City of Beverly Hills

Design Review Commission Report

Subject: **512 WALDEN DRIVE (PL1332699)**
A request for an R-1 Design Review Permit to allow the construction of a new two-story single-family residence located in the Central Area of the City north of Santa Monica Boulevard. The Commission will also consider adoption of a Categorical Exemption, pursuant to the California Environmental Quality Act.

A-10

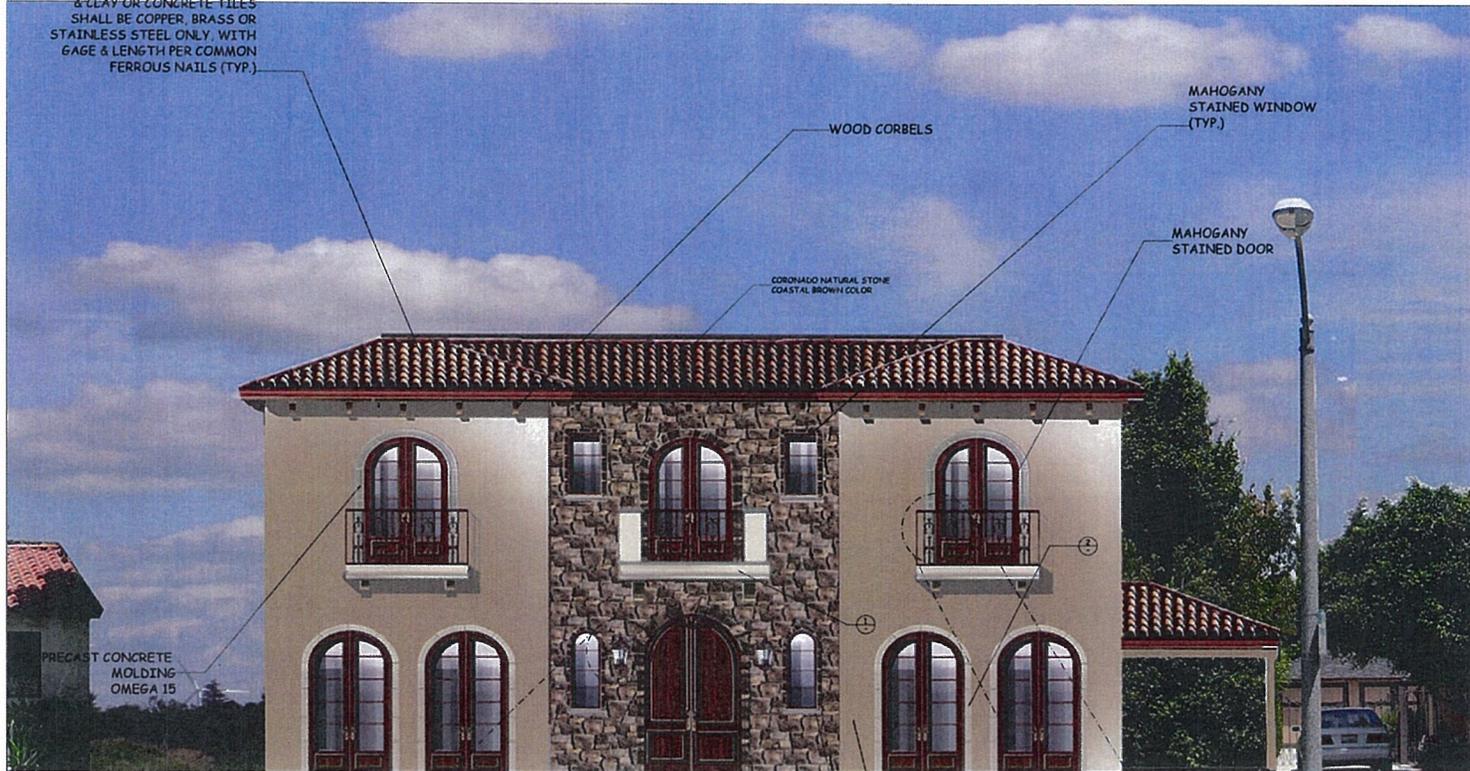
The applicant has worked to address the Commission's comments and has generally made positive improvements to the proposed single-family residence. However, there is still concern with the internal compatibility of the three façade components, materiality, and the configuration of the entry element.

EAST ELEVATION

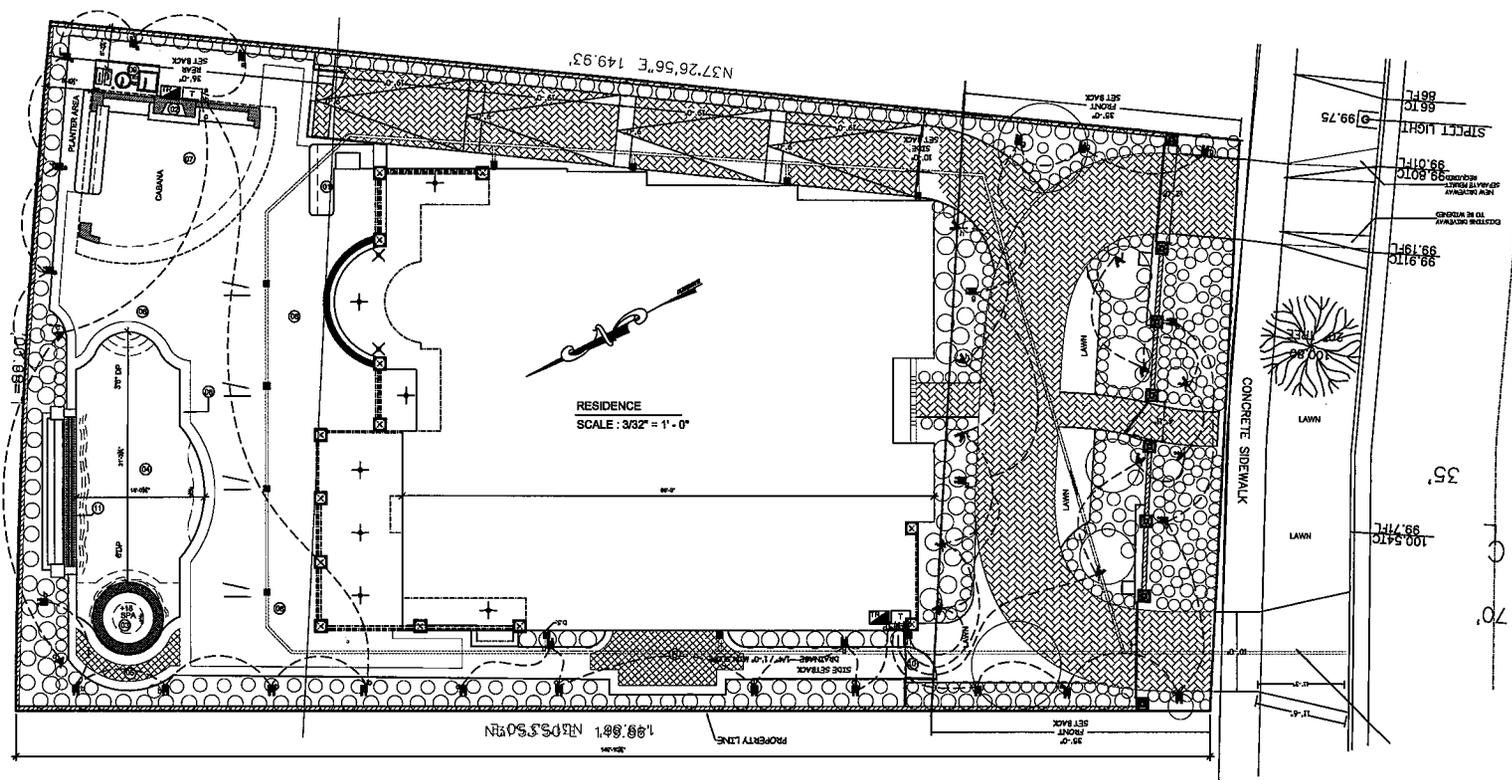
1. The proposed design has an overall lack of internal compatibility based on the proposed architectural style and design elements.

2. The façade lacks a clear entrance, as the proposed configuration is not well articulated.

3. Adjacent to the entry, the proposed tower element lacks appropriate proportion and weight, including both the width of the tower itself and the choice of window types.

4. The proposed roof slope is not appropriate for the intended style of architecture.

5. The front yard fence should also utilize alternative detailing as the proposed design is more representative of a Victorian architectural styling and does not adequately represent the Tuscan Villa styling.

- The design of the façade has been changed to be more consistent with a pure Tuscan design and has incorporated the roof feature that was present on the first submittal.

- The façade has been redesigned to provide a greater recessed entry so as to make the front door distinguishable from the other areas of the house.
- The front entry has been enhanced by adding natural stone on both the first and second floor.
- The windows located to the left and right of the entry door has also been eliminated. The window on the second floor entry has now been designed as a square window.

- The tower has now been stripped of the stone and now is stucco and the windows have been changed from arched to square.

- The slope has been changed to 7:12 which was indicated as the preferable slope by the commission.

- The fence has been simplified and now is Tuscan style and matches the railings on the second floor.

- The modulation has been simplified; there is clear hierarchy and balance and emphasis as to the entry of the house.
- Balcony on the right hand side has been partially enclosed and redesigned to provide arches with center door and two windows behind the other two arches.

- The precast molding ribbon was removed from the entry façade and only remains as to the other facades except for the tower.
- The tower is now stucco instead of stone.

- Windows on the tower are now rectangular rather than arched.
- The door at the entry has been recessed behind the stone wall. The stone has been wrapped inward to create a more authentic stone look.
